Access Compliance Report

Public Rights-of-Way

(Curb Ramps)

Intersection ID: 8611	Main Street: BROOKSHIRE_BV	Cross Street: CENTRE_ST	Location:	N
ADA ID: 1949FFD00F60	Ramp Type: BlendTrans1	Initial Pass/Fail: Fail	Overall Compliance: No	Severity Score: 10
Codes/Mitigation Info/Possible Solution		Field Measurements/Component Compliance

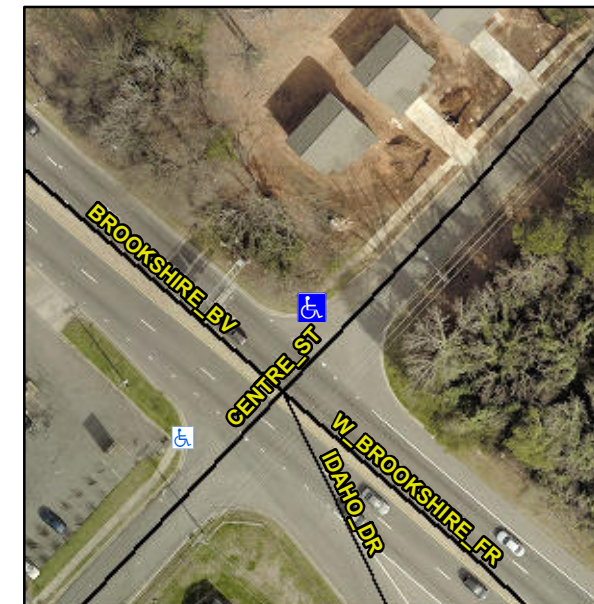
MEDIAN ACROSS BROOKSHIRE BV

Not Found, R304.5.1, R304.5.3

Compliance	Description	Data	Compliance	Description	Data
N/A	Ramp Length (in)	49.5	Yes	BlendTrans Slope (%)	3.3
No	Ramp Width (in)	47.5	No	BlendTrans XSlope (%)	3.1
N/A	Flare Type LT	N/A	N/A	Flare Type RT	N/A
N/A	Flare Slope LT (%)	N/A	N/A	Flare Slope RT (%)	N/A
N/A	Flare Traversable LT?	N/A	N/A	Flare Traversable RT?	N/A
N/A	Landing Length (in)	N/A	N/A	DWS Provided?	N/A
N/A	Landing Width (in)	N/A	N/A	DWS Contrast?	N/A
N/A	Landing Slope (%)	N/A	N/A	DWS Length (in)	N/A
N/A	Landing X Slope (%)	N/A	N/A	DWS Full Width?	N/A
N/A	Landing Curb? (Y/N)	N/A	N/A	DWS Offset (in)	N/A
N/A	Shared Landing?	N/A			
N/A	Gutter Ponding?	N/A	N/A	Gutter Slope (%)	N/A
N/A	Gutter Lip Ht (in)	3.5	N/A	Gutter X Slope (%)	N/A
N/A	Painted X Walk1?	No	N/A	Painted X Walk2?	N/A
	X Walk 1 Direction	To SE		X Walk 2 Direction	N/A
	X Walk 1 Width (in)	N/A		X Walk 2 Width (in)	N/A
	X Walk 1 Slope (%)	0.1		X Walk 2 Slope (%)	N/A
	X Walk 1 X Slope (%)	16.1		X Walk 2 X Slope (%)	N/A

N/A	Ramp inside XWalk1?	N/A	N/A	Ramp inside XWalk2?	N/A
	Road Slope (%)	9.9		Clear Space?	N/A
	Road X Slope (%)	0.1	N/A	Clear Space to XWalk (in)	N/A
N/A	Any Obstructions?	N/A	N/A	Storm Grate/Utility Hazard?	N/A
	Obstruction Type			Storm Grate/Utility Type	
		N/A			N/A
			Yes	Surface Condition? (G/P)	Good
			No	Curb Slope (%)	26.4

Remove & Replace Curb Ramp With Two New Directional Ramps or Equivalent.
